RESPONSE TO COMMENTS

Darigold Inc.
NPDES Permit ID0024953
February 19, 2019

This Response to Comments document provides a summary of significant comments received and corresponding EPA responses.

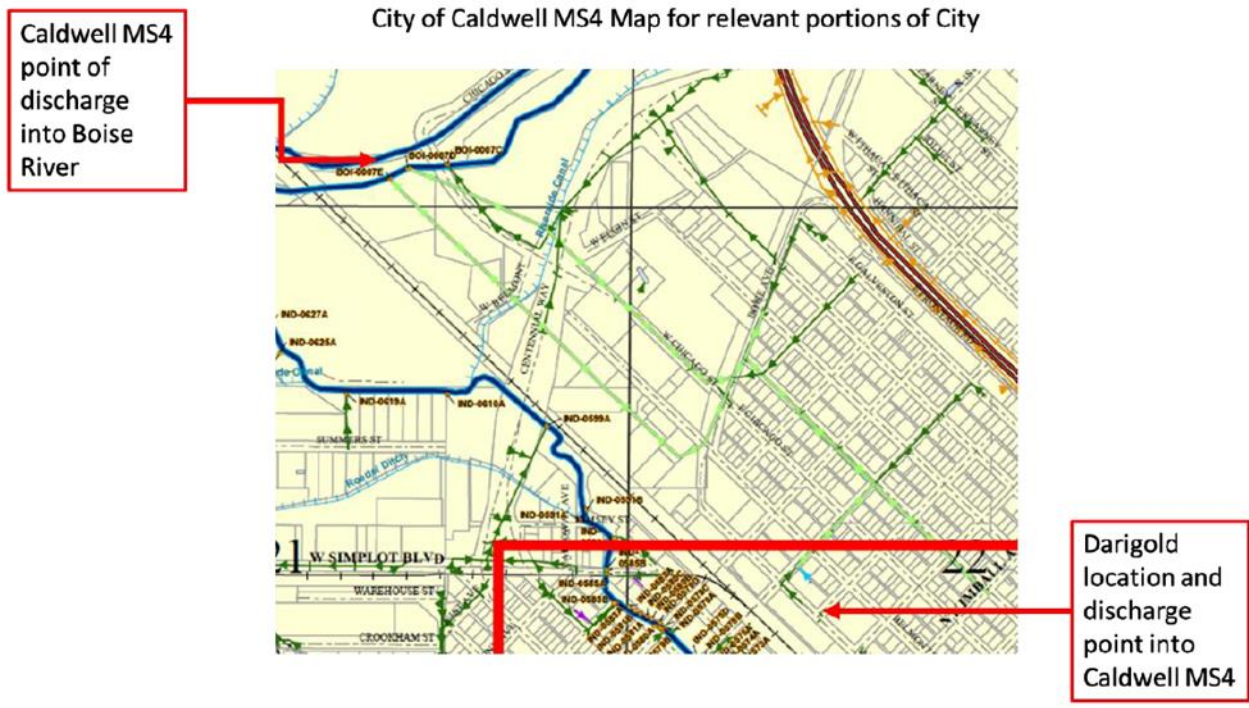
The EPA disagrees that the monitoring data indicates that the current discharge will not always be in compliance with the pH range limitation, both on the low and high end of the range and will involve a more complex control system than if the compliance challenge was on one end of the range.

In the last five years Darigold has never exceeded the lower pH limit and has only exceeded the upper pH limit once in the last five years. The table below shows recent data.

Therefore, a compliance schedule is not required for Darigold to meet the effluent limits for pH.

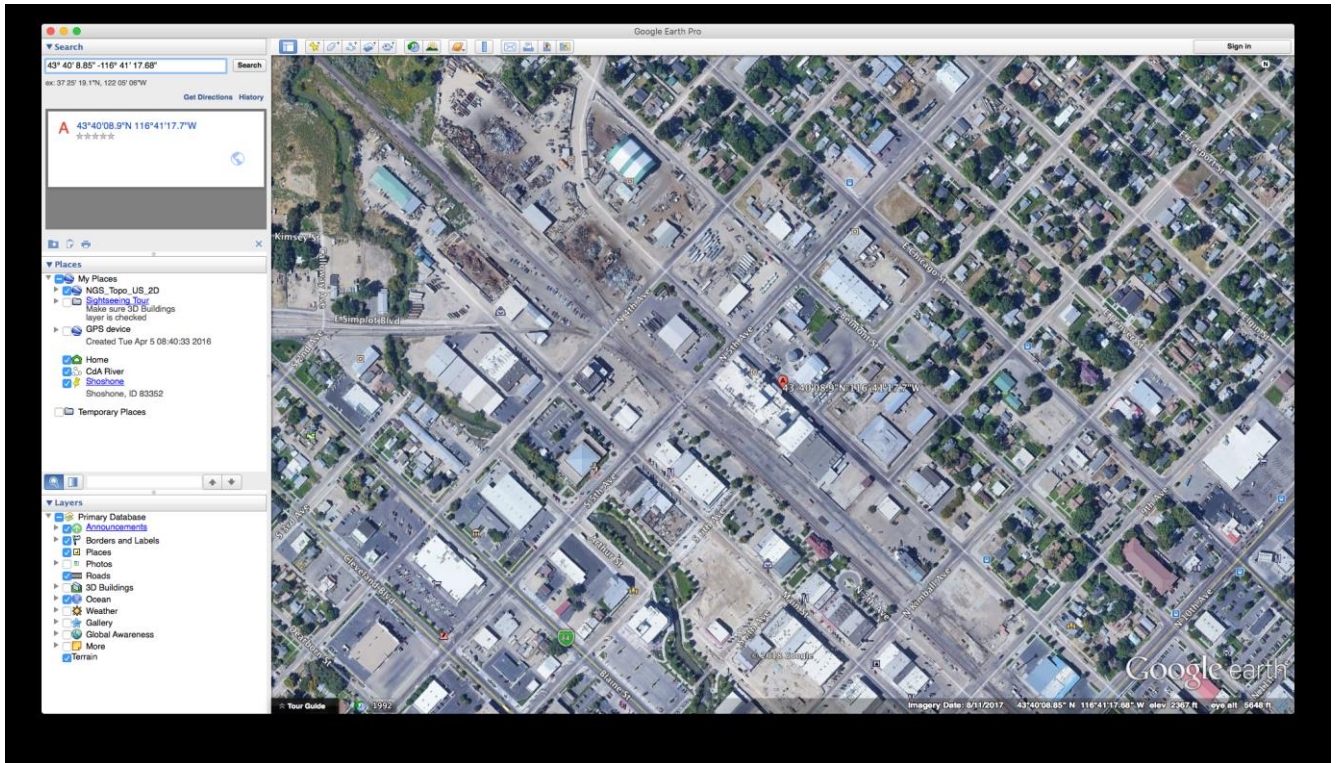
12. Comment: (ICL) Effluent Limit Ammonia

Appendix D of the Fact Sheet shows the Reasonable Potential Analysis (RPA) for ammonia. The RPA determined that ammonia discharges from this facility did not have a reasonable potential to exceed water quality standards; however, this result is contingent on a number of factors, including that ammonia concentrations in the effluent do not exceed 8,590 µg/L. We encourage the EPA to include 8,590 µg/L as an effluent limit for ammonia given that the results of the RPA are only valid if this value is not exceeded.

Further, under “Critical River Flows,” 234 cfs is listed as the 30B3/30Q10 Annual Critical Flow rather than the 30Q5 critical flow, differing from Table 4 in the Fact Sheet. We are concerned that the RPA calculations relying on this value may be inaccurate if the incorrect critical flow was used. We request that the EPA ensure the correct values are utilized for the critical low-flow values (i.e using 234 cfs as the 30Q5 flow) and that the RPA for ammonia be redone using the correct values to ensure the final results are correct and accurate.

Response: As the fact sheet states using procedures in the Technical Support Document, the reasonable potential multiplying factor (RPMF) is used to derive the maximum projected effluent concentration (Ce). Using the RPMF and the 95th percentile representing the highest reported concentration discharge concentration a reasonable potential to violate the water quality standards for ammonia is derived. If there is no reasonable potential to violate the ammonia during these worst case conditions there is no necessity to establish an effluent limitation for ammonia. The Fact Sheet concluded using these procedures there is no reasonable potential to violate the water quality standard for ammonia under these worst case conditions and therefore an effluent limitation is not required and not established.

The spreadsheet is mislabeled. It should say on the line for chronic ammonia critical flow 30B3/30Q10/**30Q5**. These long term averages can all be used to determine the reasonable potential to violate the chronic ammonia water quality standards.

Spread of a Plume from a Point Source in a River with Boundary Effects from the Shoreline

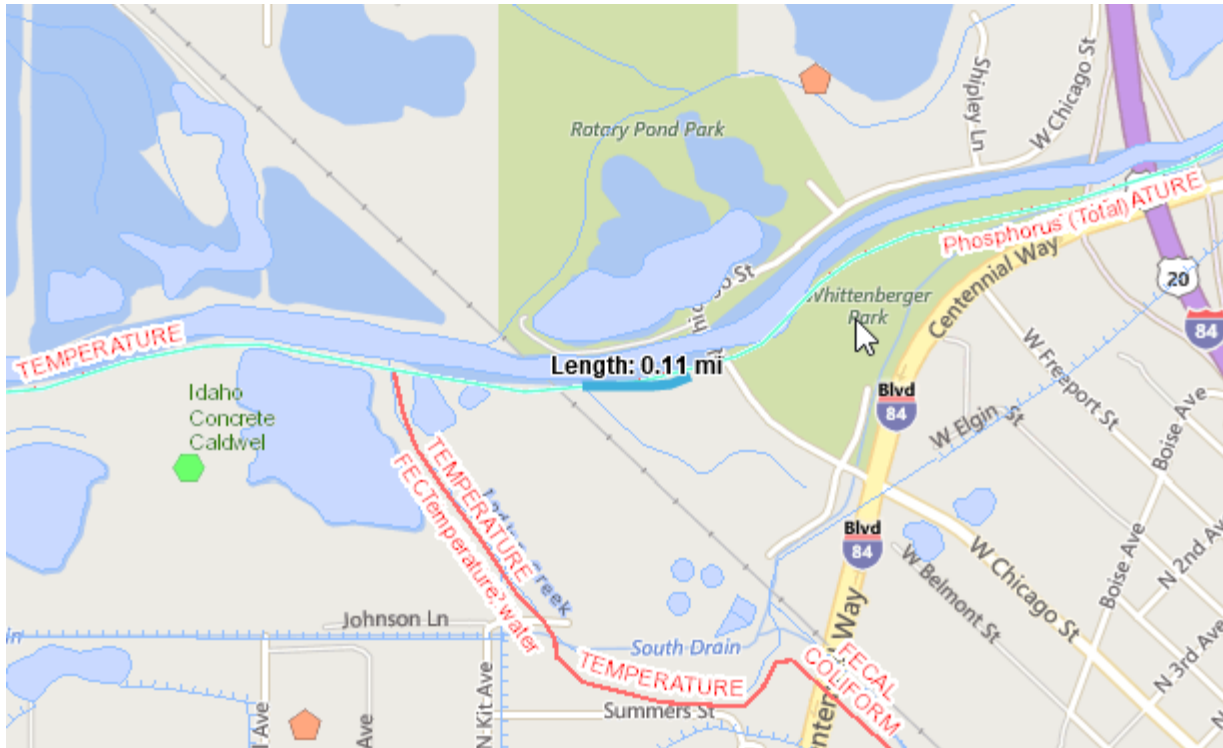
15. Comment: (ICL) Appropriateness of Utilizing Mixing Zone

Idaho DEQ (IDEQ) is proposing a 10% mixing zone for ammonia as part of this permit and 401 Certification. We have concerns over the appropriateness of mixing zones for this facility given the outfall locations proximity to the City of Caldwell’s WWTP. There is likely overlap between these two discharges; thus, the typical dilution assumptions accompanying mixing zone decisions may not be applicable (i.e. the efficacy of dilution in waters being simultaneously polluted by a different source). We request that the EPA and or IDEQ explain their consideration of this scenario and discuss any analysis that was performed to assess the appropriateness of a mixing zone for this discharge.

Response: The EPA used Riverplume6 dispersion modeling and measurements in the vicinity of the outfall to the Boise River to determine the impacts to the City of Caldwell 580 feet downstream. River depth came from the 1999 USGS publication *Stream Channel Cross Sections for a Reach of the Boise River in Ada County, Idaho*. Complete mixing occurs approximately 164 feet downstream of the Darigold outfall well before impacting the mixing zone for the City of Caldwell 580 feet downstream. Therefore the mixing zone analysis is appropriate. The spreadsheet is shown below.

The permit is unchanged based on the comment.
